Environmental Planning Commission

Staff Report

Agenda Item Number: 2
Project #: PR-2023-008617
Case #: SI-2023-00866
Hearing Date: June 15, 2023

Agent	Consensus Planning
Applicant	ABCWUA
Request	Site Plan – EPC, Major Amendment
Legal Description	All of Section 28, Township 11 North, Range 2 East
Location	6641 81 st Street NW, between Molten Rock NW and 81 st Street NW
Size	An approximately 4.8-acre portion of a 640-acre site
Existing Zoning	NR-PO-B

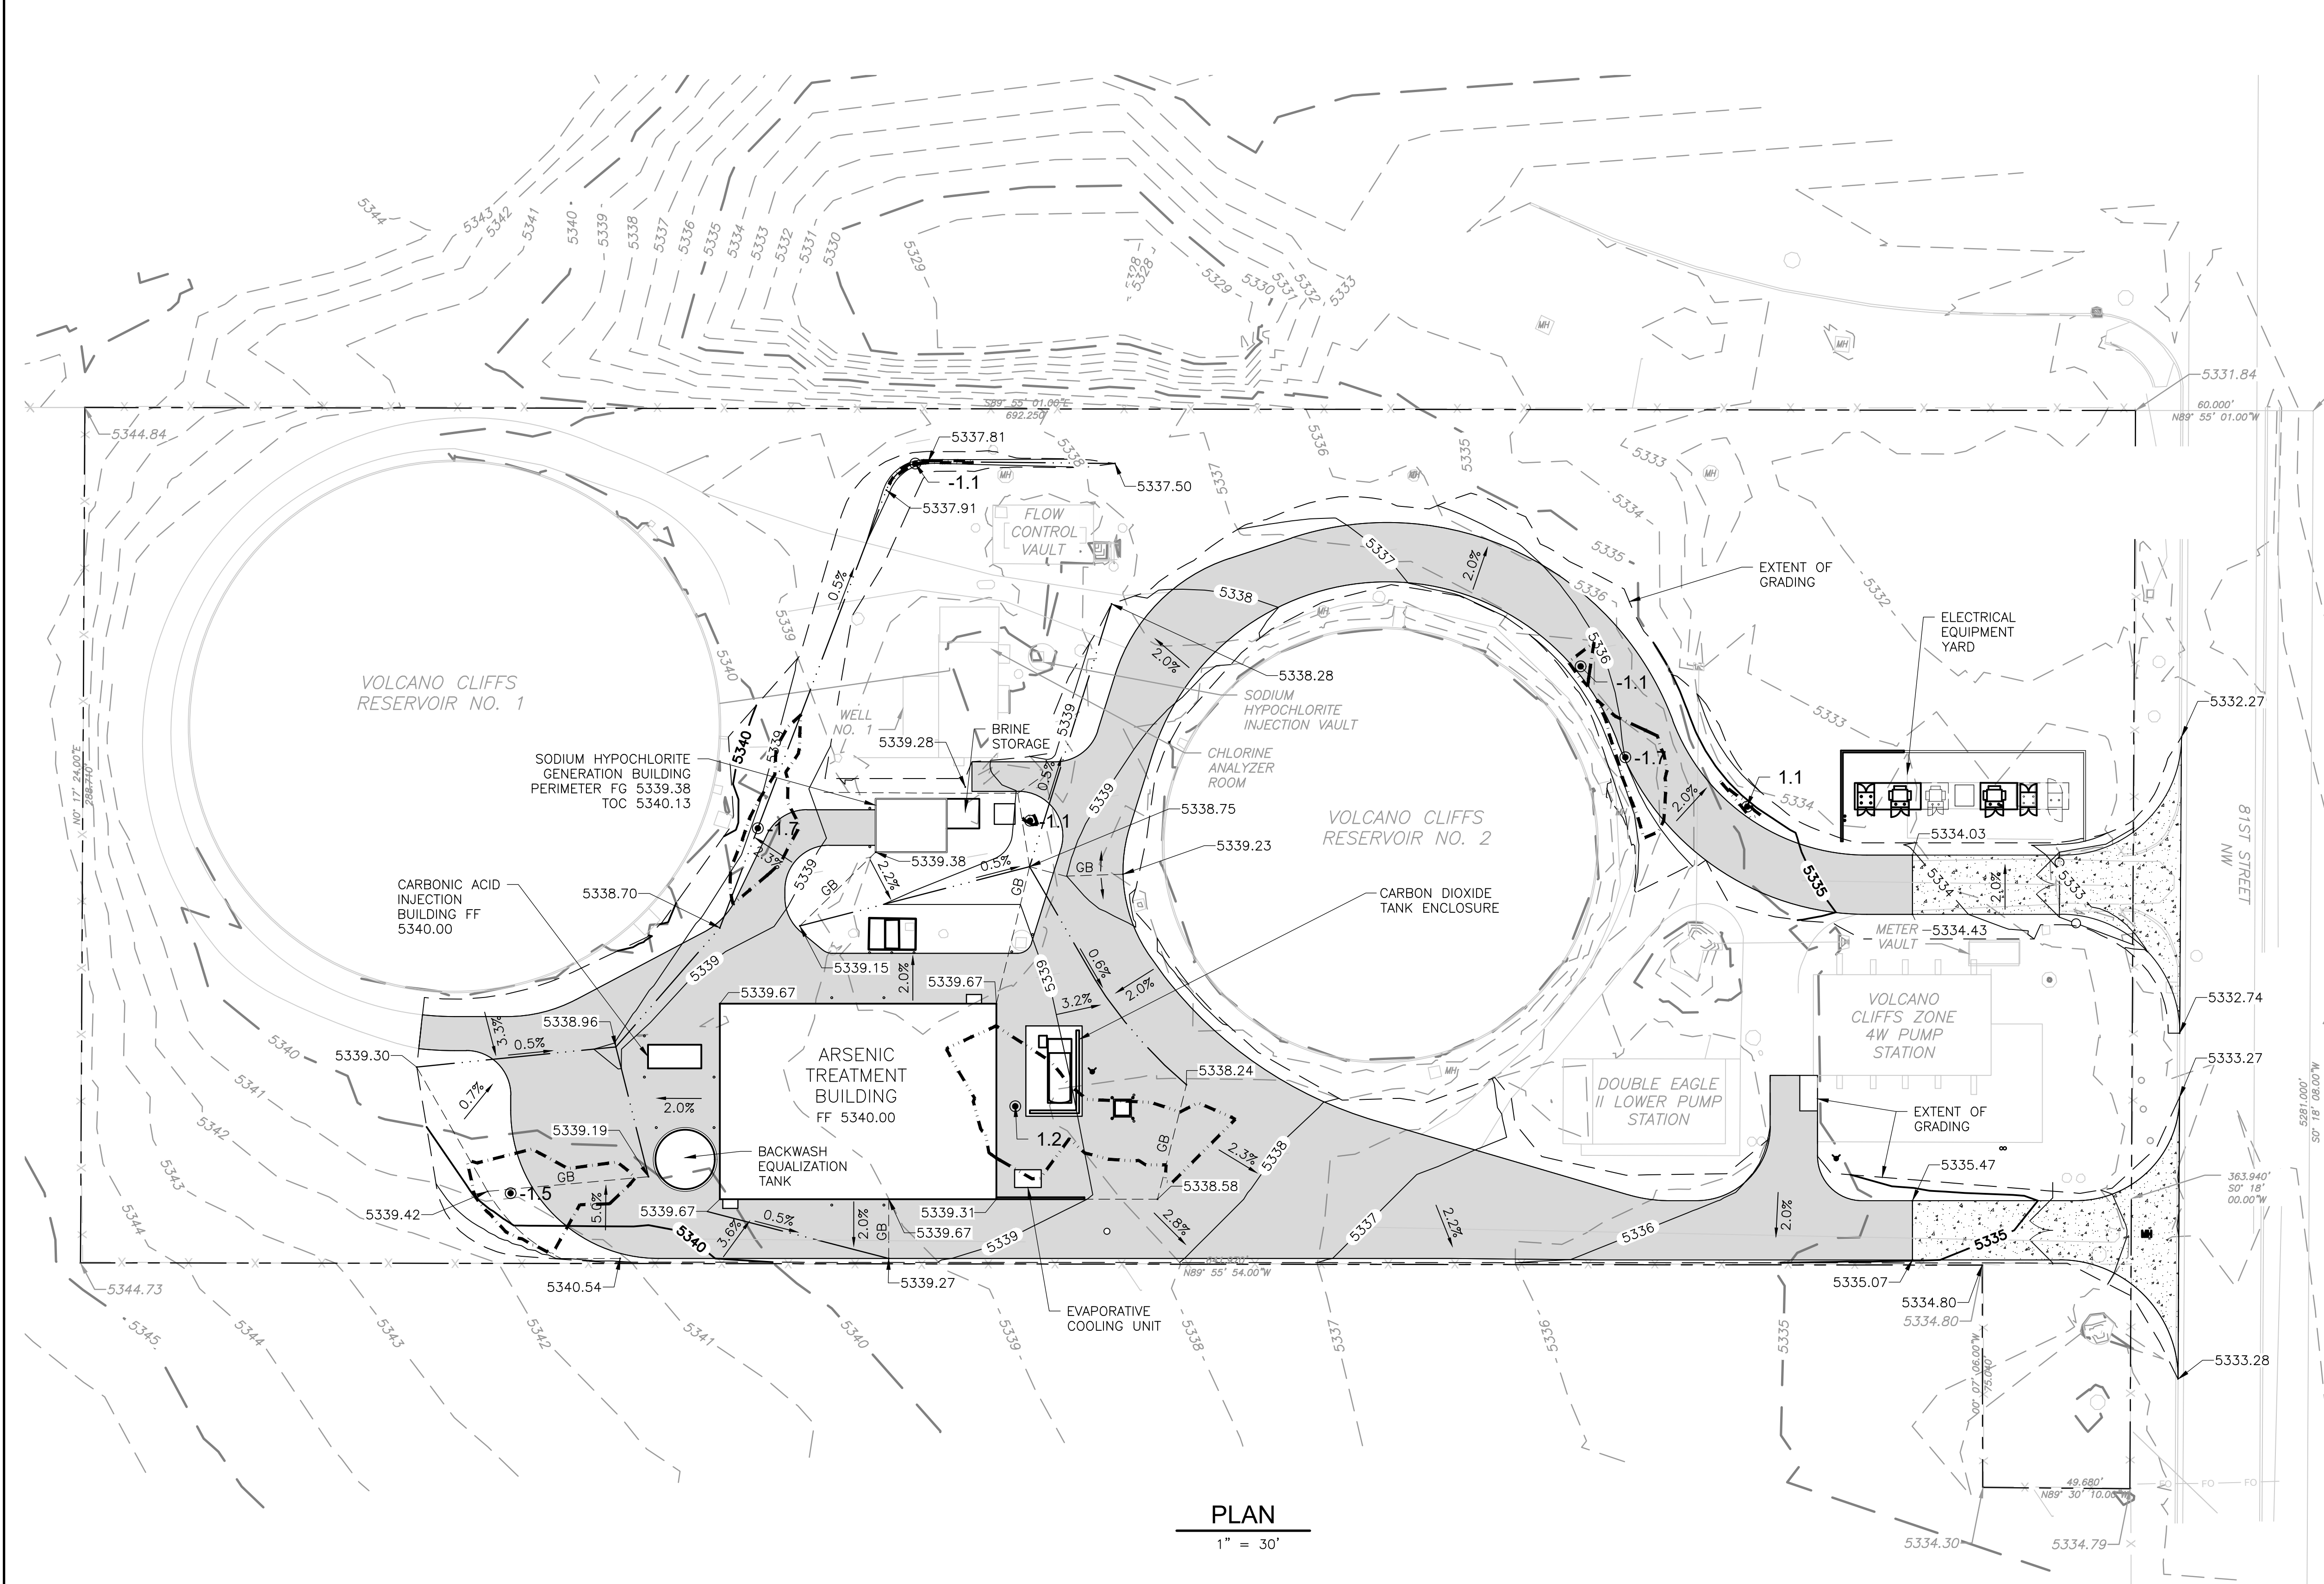
The grading and drainage plan (Sheet C9) list existing slopes within the improvement area consists of gentle slopes between 0 and 10%. However, 80% of the site is below a 5% slope. The area west and southwest of the site boundary slopes 2% to 7% towards the site but there is a steep slope down from the north boundary. Proposed grades around the site are most 5% or less. There are no retaining walls or grade changes larger than 4 feet on the site.

The Utility Plan (Sheet C-9) was submitted as part of the application packet. The Utility Plan shows proposed well collector lines, finished water, bypass lines along with a backwash supply line. A 2" potable water line is shown, fire hydrants, and gas meter. .

LANDSCAPE
PLAN

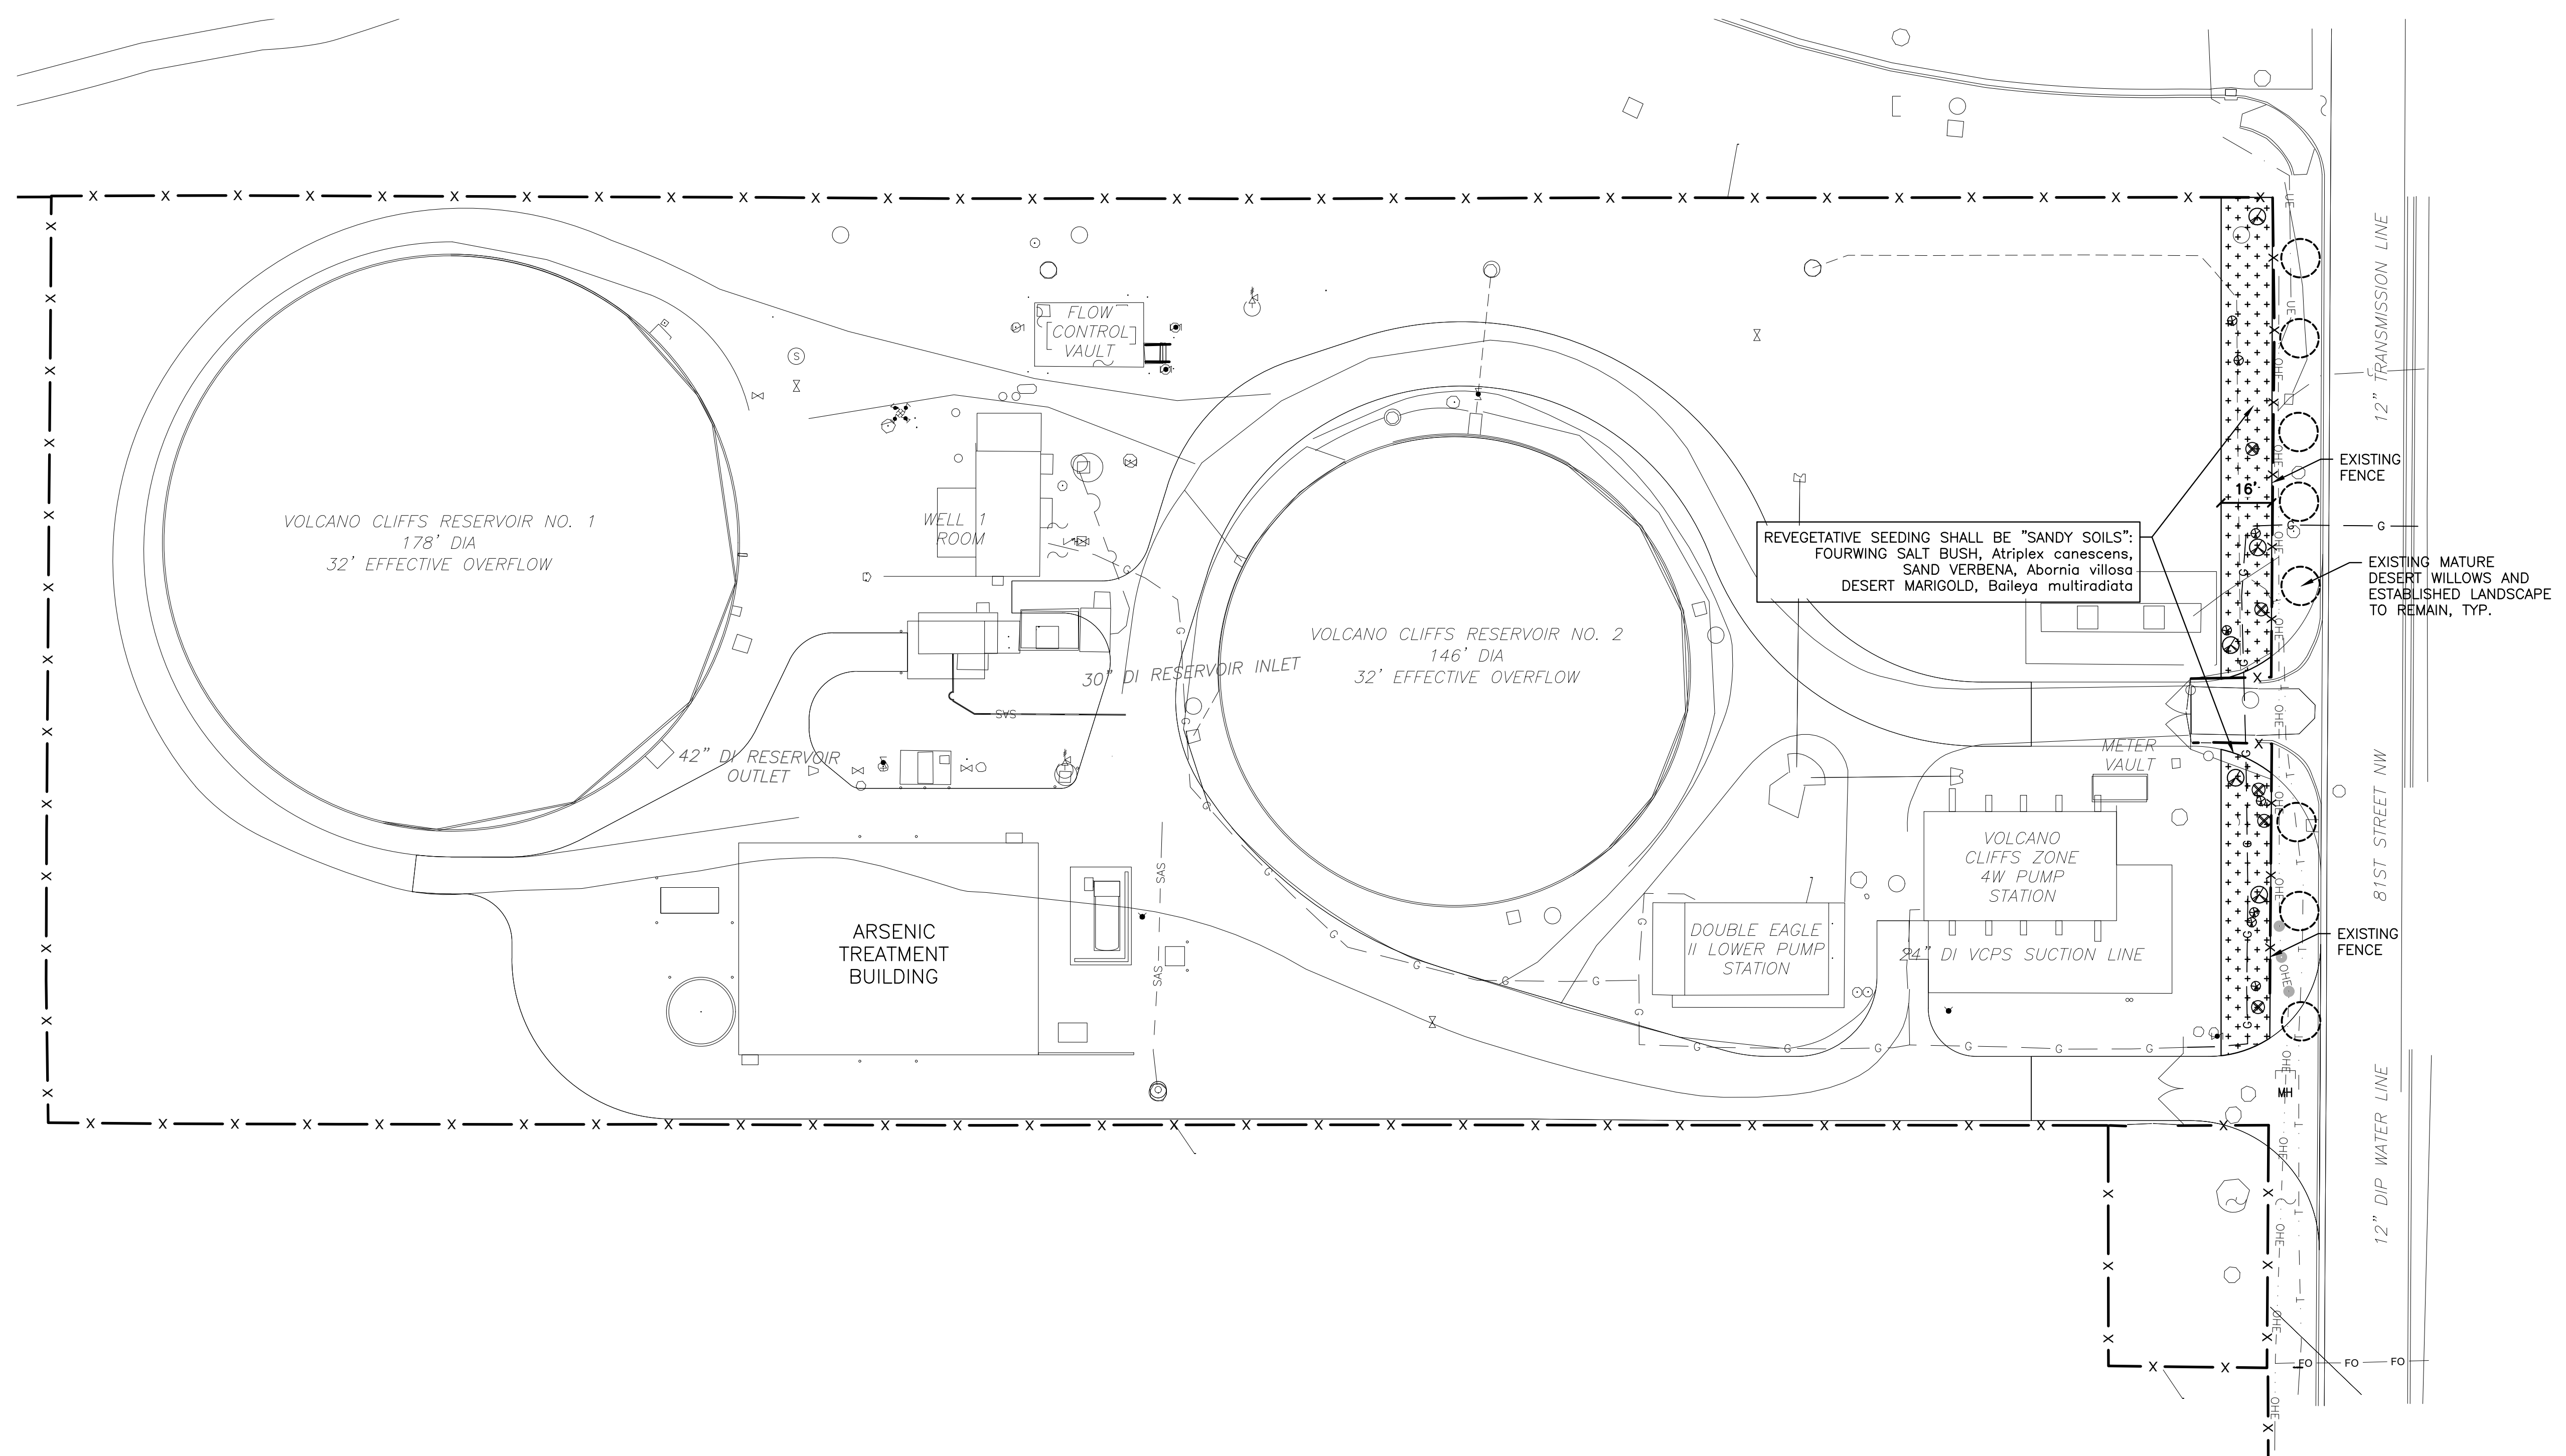
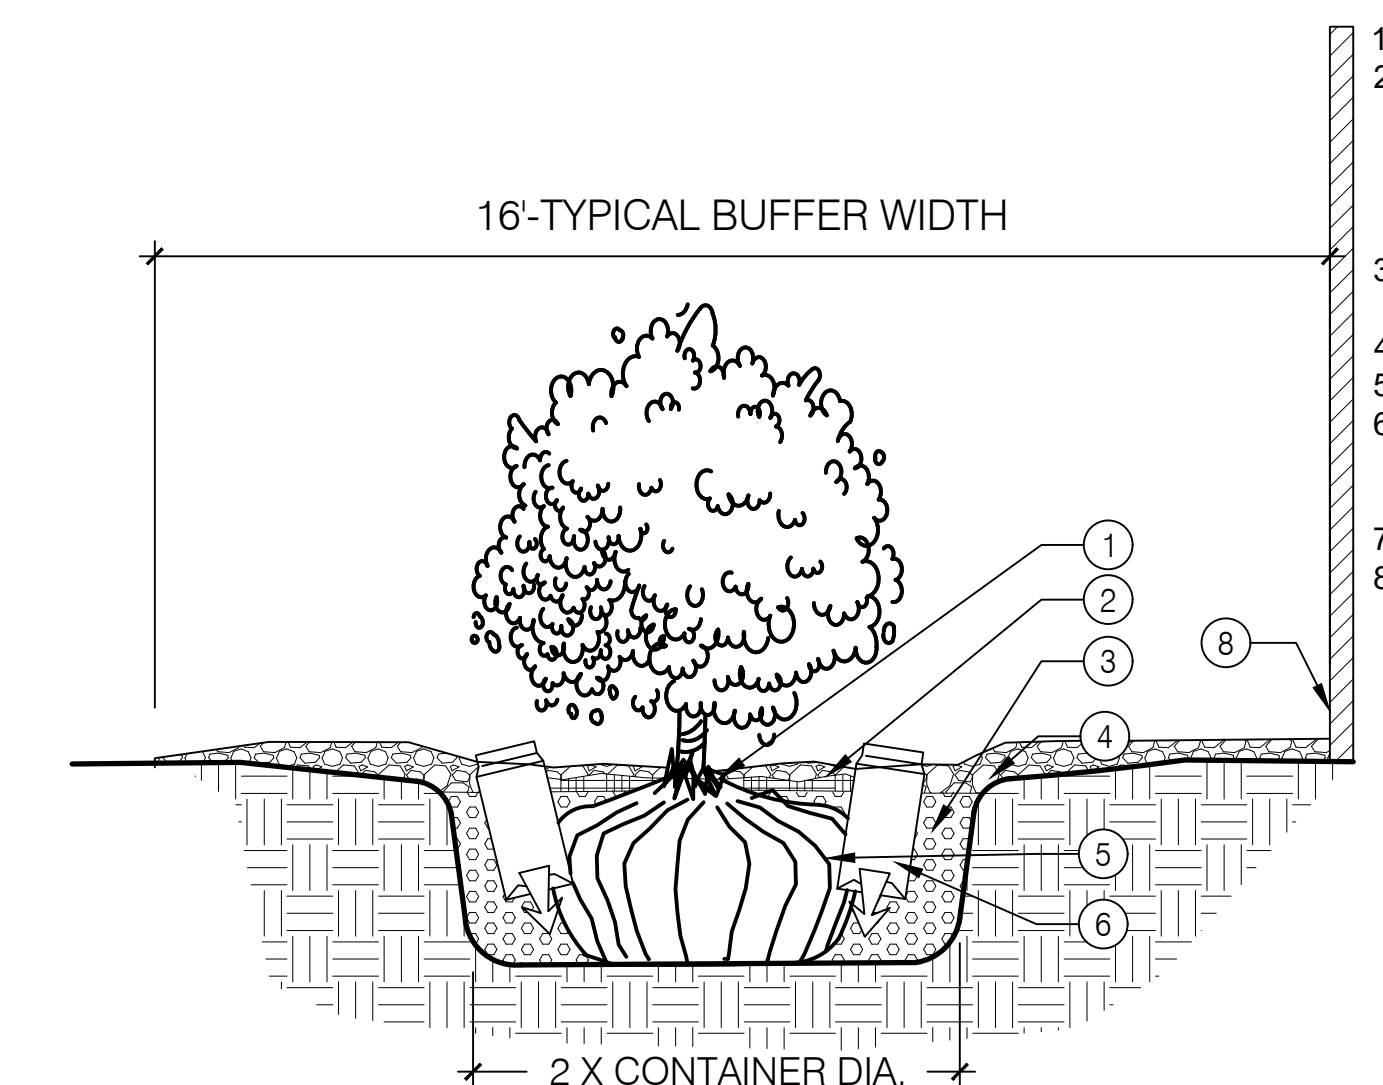
All areas disturbed by construction activities will be drill seeded and hydro-mulched to the extents of the disturbance. New shrubs will be hand watered. Please refer to the Landscape Plan (LS100) for details on native shrub planting with irrigation supplementation.
